Access Compliance Report

Public Rights-of-Way

Intersection ID: 10955	Main Street: ROBINSON_CHURCH_RD	Cross Street: CASTLE_GARDEN_LN	Location: N
ADA ID: F5C7A0995D78	Ramp Type: Perp	Initial Pass/Fail: Fail	Overall Compliance: No
Severity Score: 21.25			
Codes/Mitigation Info/Possible Solution		Field Measurements/Component Compliance

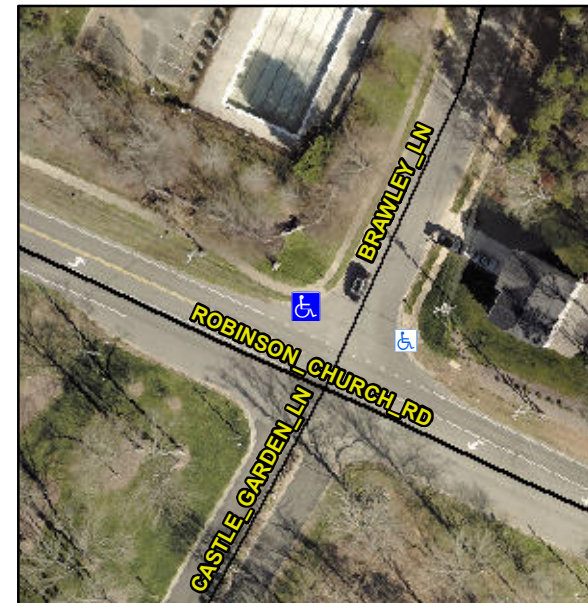
Not Found, R304.5.1, R304.2.2

Compliance	Description	Data	Compliance	Description	Data
N/A	Ramp Length (in)	48.0	No	Ramp Slope (%)	10.1
No	Ramp Width (in)	43.5	Yes	Ramp XSlope (%)	0.6
N/A	Flare Type LT	N/A	N/A	Flare Type RT	N/A
N/A	Flare Slope LT (%)	N/A	N/A	Flare Slope RT (%)	N/A
N/A	Flare Traversable LT?	N/A	N/A	Flare Traversable RT?	N/A
N/A	Landing Length (in)	N/A	N/A	DWS Provided?	N/A
N/A	Landing Width (in)	N/A	N/A	DWS Contrast?	N/A
N/A	Landing Slope (%)	N/A	N/A	DWS Length (in)	N/A
N/A	Landing X Slope (%)	N/A	N/A	DWS Full Width?	N/A
N/A	Landing Curb? (Y/N)	N/A	N/A	DWS Offset (in)	N/A
N/A	Shared Landing?	N/A			
N/A	Gutter Ponding?	N/A	N/A	Gutter Slope (%)	N/A
N/A	Gutter Lip Ht (in)	N/A	N/A	Gutter X Slope (%)	N/A
N/A	Painted X Walk1?	No	N/A	Painted X Walk2?	N/A
	X Walk 1 Direction	To SE		X Walk 2 Direction	N/A
N/A	X Walk 1 Width (in)	N/A	N/A	X Walk 2 Width (in)	N/A
	X Walk 1 Slope (%)	2.9		X Walk 2 Slope (%)	N/A
	X Walk 1 X Slope (%)	2.8		X Walk 2 X Slope (%)	N/A

Remove & Replace Entire Ramp.
